SR-400 CYCLONE AND CYCLONE II PA UPGRADE TO 6KD6

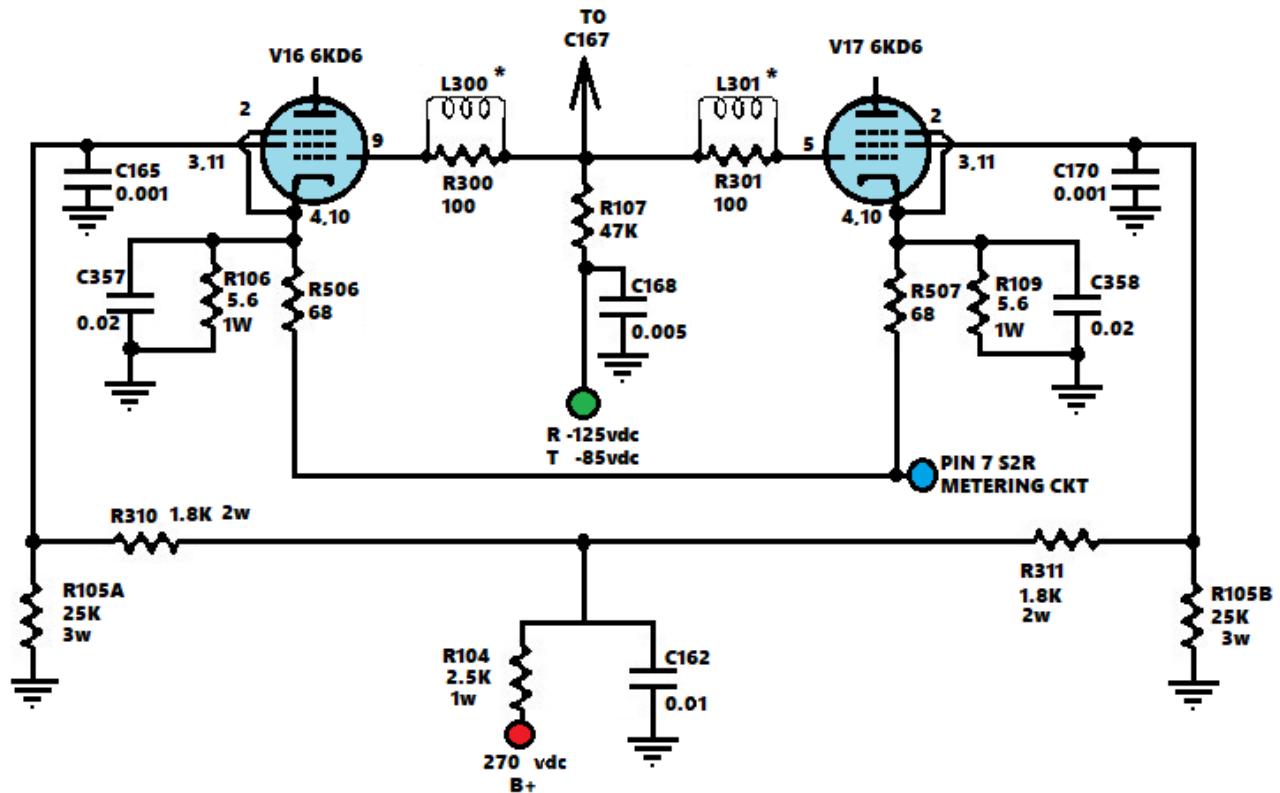
This schematic reflects the changes on the socket side of the PA enclosure. The tube side of the enclosure has no changes.

*** Five turns of #24 wire around the 100 ohm resistors.**
